EARLY DESIGN GUIDANCE OF THE NORTHWEST DESIGN REVIEW BOARD

Project Number: 3012205

Address: 2034 NW 56th St

Date of Meeting: Monday, July 11, 2011

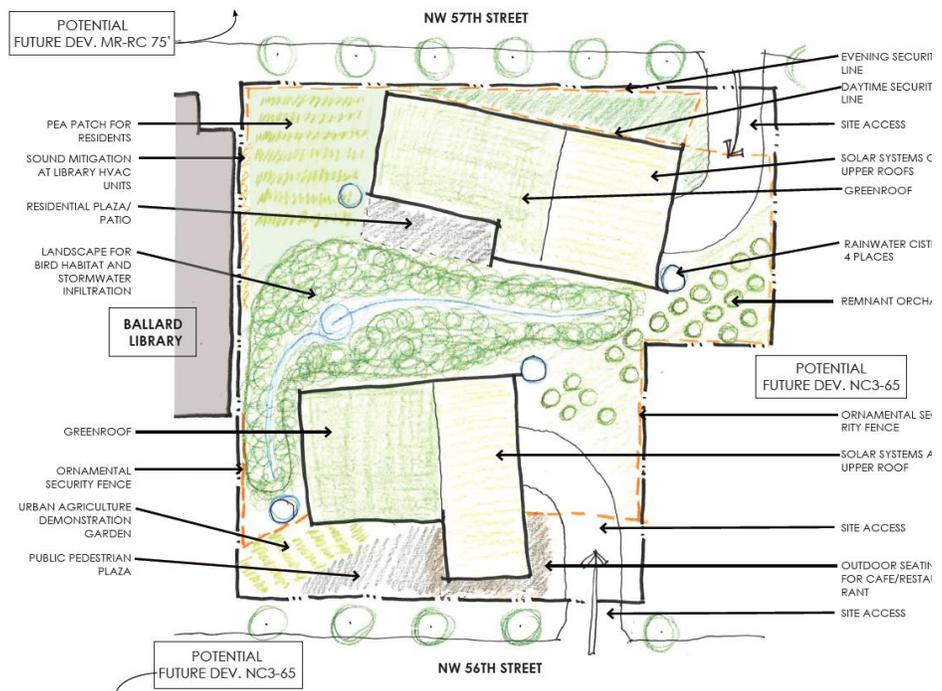
At the Early Design Guidance Meeting, the Board noted that the proposed Alternative 4 massing will present a street frontage that doesn’t respond to nearby streetscape development at the property line, but this could be an interesting break in the fabric.

The applicant should provide more information at the Recommendation stage of review indicating how the proposed streetscape design would create positive spatial characteristics and relate to the nearby streetscape.

At the Early Design Guidance Meeting, the Board reiterated guidance from A-2, and specified that more information is needed about the building entries' relationships to the street at NW 56th St and NW 57th St. The live-work units, the residential entry, the office entry, and the restaurant/café entry require different design treatments. The applicant should identify how the entries respond to this guideline.

At the Early Design Guidance Meeting, the Board discussed the importance of designing the parking access points to enhance the street frontages. The curb cuts are proposed at the east edges of the site and the driveways curve around to the garage entries, which will have a visual effect on the streetscape and on adjacent properties. The applicant should carefully design these areas with a “woonerf” style approach to improve appearance and pedestrian safety, using techniques such as special paving, landscaping, decorative light fixtures, traffic calming, etc.
